Verification Report

006

McAlear & Rushe

101 Charles Street

VERIFICATION LAYOUT

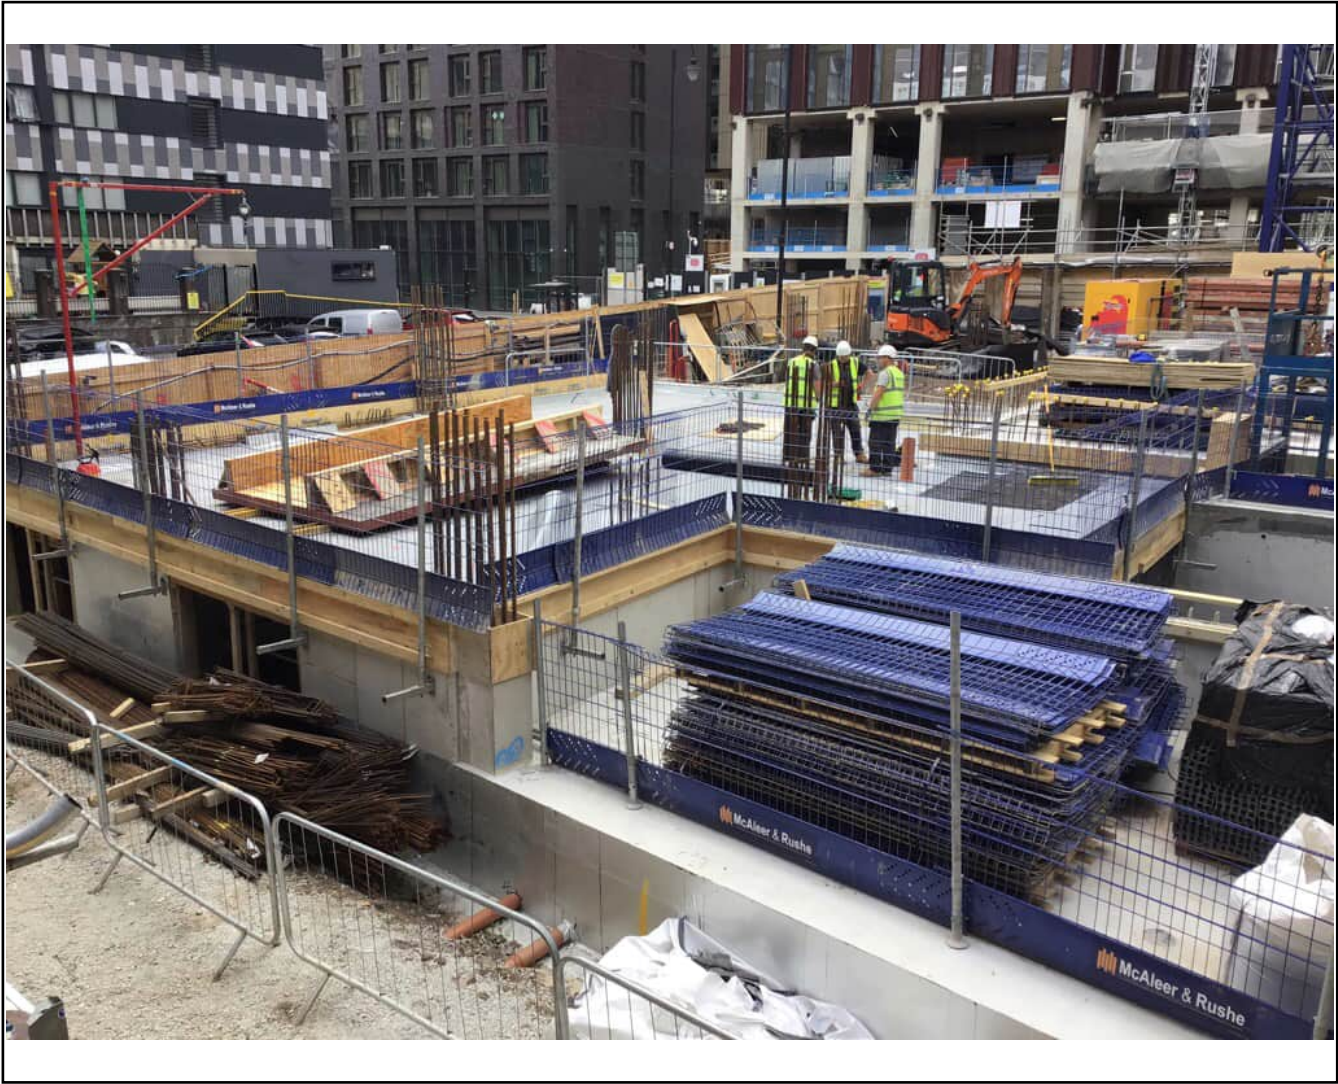
Gridlines 11/6:E/G, Gridlines 6/4:A/C and ring beams to 3/1:E/G

Verified in this report as highlighted above

ADDITIONAL PHOTOGRAPHS

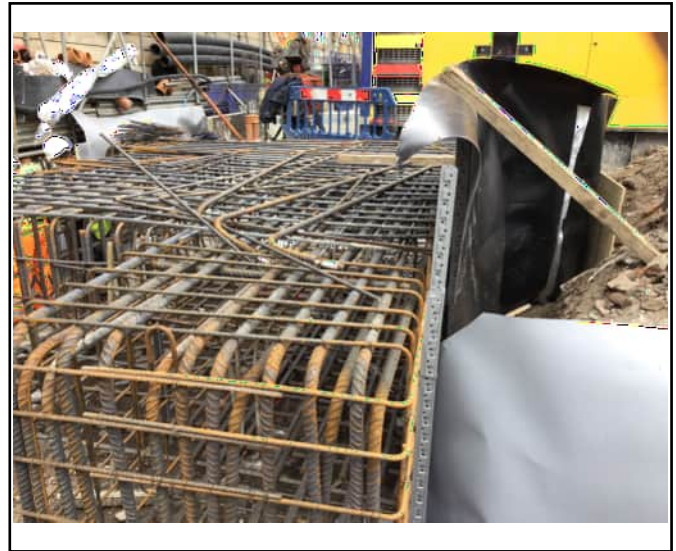
Visqueen Geoseal beneath ring beam

to 3/1:E/G

Visqueen Geoseal beneath

steel rebar 300mm as design detail

Penetrations in Gridlines 11/6:E/G

sealed to a good standard

ADDITIONAL PHOTOGRAPHS

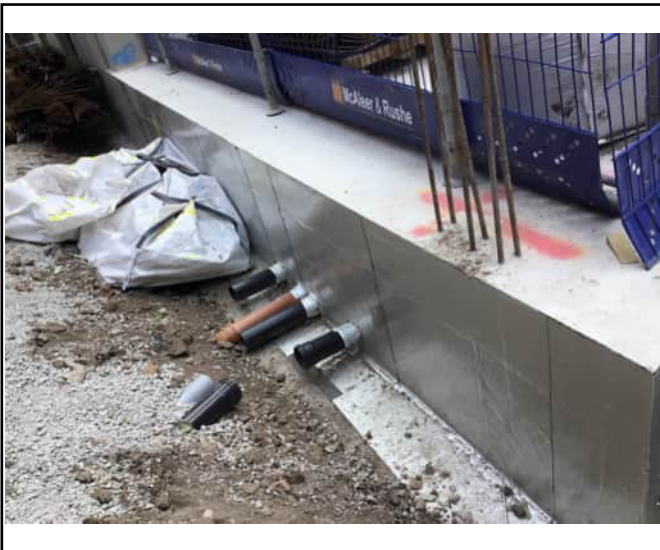
Perimeter to Gridlines 11/6:E/G

sealed to a good standard

Perimeter detail sealed with no

faults found

Pick and probe test to perimeter

detail. Good bond and overlaps
